LIPSCOMB-JACKSON SUBDIVISION

Revised for the October 3, 2013 meeting:

APPLICATION NUMBER 2 DATE October 3, 2013

SITE PLAN

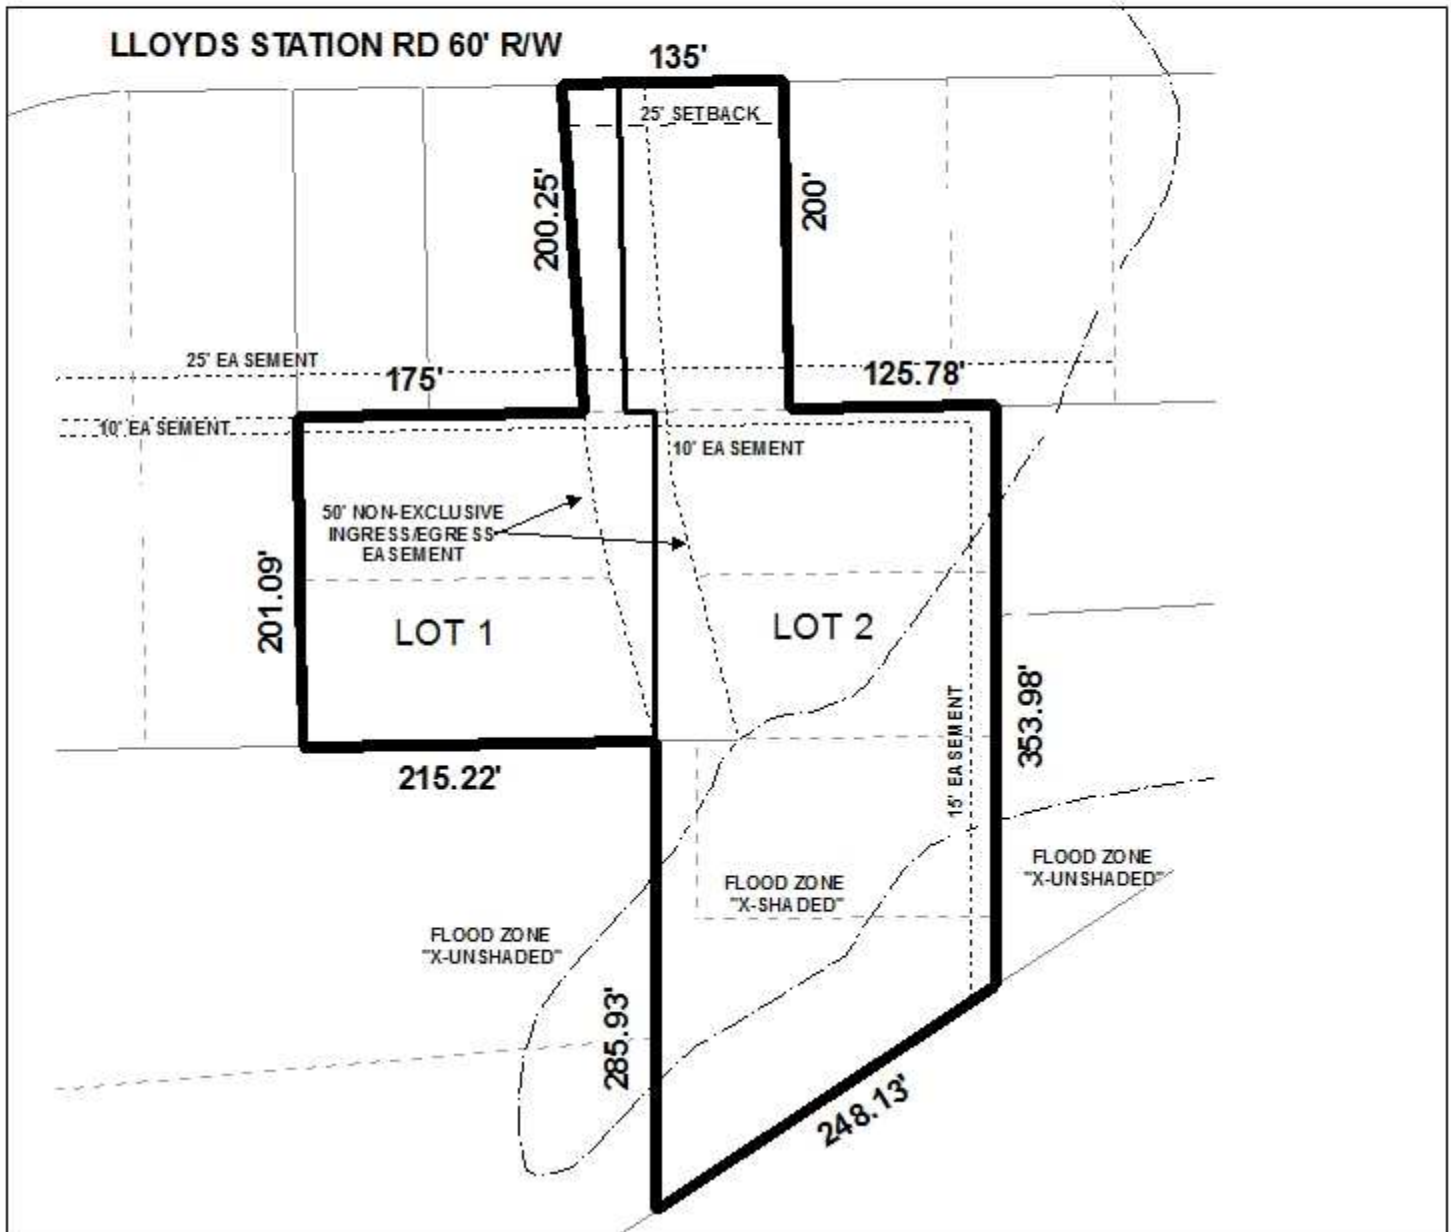
There seems to be several discrepancies with the preliminary plat. The lot size information is not depicted for either lot and the 25-foot minimum setback line for Lot 1 should be revised and depicted as a box where the "Flag" meets the "Pole" of the lot if approved. Also, the Point of Beginning location should be revised as well, as they appear to contain errors.

Staff has verified the applicant's claims; however the preliminary plat depicts a 50' easement and the applicant has not indicated whether the existing easement will be upgraded. It is recommended that the Final Plat be revised to depict a 50' private right-of-way in lieu of the 50' easement in addition to a note stating that no permanent structures be constructed in any easement or private right-of-way. The construction of any new street is to comply with Section VIII.E of the Subdivision Regulations and be approved by Engineering. A note should appear on the Final Plat, if approved, to reflect this requirement.

- 1) The lot size information in square feet and acres should be depicted on the Final Plat;*
- 2) The 25' minimum setback line should be revised for Lot 1 and depicted where the "Flag" meets the "Pole" on the Final Plat;*
- 3) The Point of Beginning location should be revised on the Final Plat;*
- 4) The Final Plat should be revised to depict a 50' private right-of-way in lieu of the 50' easement and a note stating that no permanent structures be constructed in any easement or private right-of-way;*
- 5) Placement of a note on the Final Plat stating: (The construction of new streets must comply with Section VIII.E of the Subdivision Regulations and be approved by Engineering)*
- 6) Placement of a note on the Final Plat stating: (Lots 1 and 2 are limited to one curb-cut each, with the size, design or location to be approved by Traffic Engineering and comply with AASHTO standards);*
